Access Compliance Report

Public Rights-of-Way

(Curb Ramps)

Intersection ID: 47651	Main Street: MULLAN_LN	Cross Street: MORAY_CT	Location: NE
ADA ID: 2BD199B1439E	Ramp Type: BlendTrans2	Initial Pass/Fail: Fail	Overall Compliance: No
Severity Score: 8.75			
Codes/Mitigation Info/Possible Solution		Field Measurements/Component Compliance

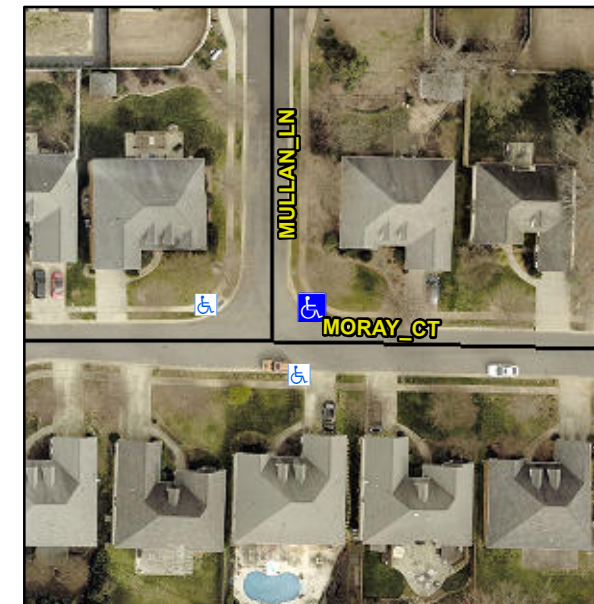
Not Found, R304.5.1

Compliance	Description	Data	Compliance	Description	Data
N/A	Ramp Length (in)	97.5	Yes	BlendTrans Slope (%)	3.2
No	Ramp Width (in)	44.0	Yes	BlendTrans XSlope (%)	1.4
N/A	Flare Type LT	N/A	N/A	Flare Type RT	N/A
N/A	Flare Slope LT (%)	N/A	N/A	Flare Slope RT (%)	N/A
N/A	Flare Traversable LT?	N/A	N/A	Flare Traversable RT?	N/A
N/A	Landing Length (in)	N/A	N/A	DWS Provided?	N/A
N/A	Landing Width (in)	N/A	N/A	DWS Contrast?	N/A
N/A	Landing Slope (%)	N/A	N/A	DWS Length (in)	N/A
N/A	Landing X Slope (%)	N/A	N/A	DWS Full Width?	N/A
N/A	Landing Curb? (Y/N)	N/A	N/A	DWS Offset (in)	N/A
N/A	Shared Landing?	N/A			
N/A	Gutter Ponding?	N/A	N/A	Gutter Slope (%)	N/A
N/A	Gutter Lip Ht (in)	N/A	N/A	Gutter X Slope (%)	N/A
N/A	Painted X Walk1?	No	N/A	Painted X Walk2?	No
	X Walk 1 Direction	To W		X Walk 2 Direction	To S
	X Walk 1 Width (in)	N/A		X Walk 2 Width (in)	N/A
	X Walk 1 Slope (%)	1.5		X Walk 2 Slope (%)	0.0
	X Walk 1 X Slope (%)	1.6		X Walk 2 X Slope (%)	1.5

N/A	Ramp inside XWalk1?	N/A	N/A	Ramp inside XWalk2?	N/A
	Road Slope (%)	0.5		Clear Space?	N/A
	Road X Slope (%)	2.3	N/A	Clear Space to XWalk (in)	N/A
N/A	Any Obstructions?	N/A	N/A	Storm Grate/Utility Hazard?	N/A
	Obstruction Type			Storm Grate/Utility Type	
		N/A			N/A
			Yes	Surface Condition? (G/P)	Good
			No	Curb Slope (%)	9.9

Remove & Replace Curb Ramp With Two New Directional Ramps or Equivalent.
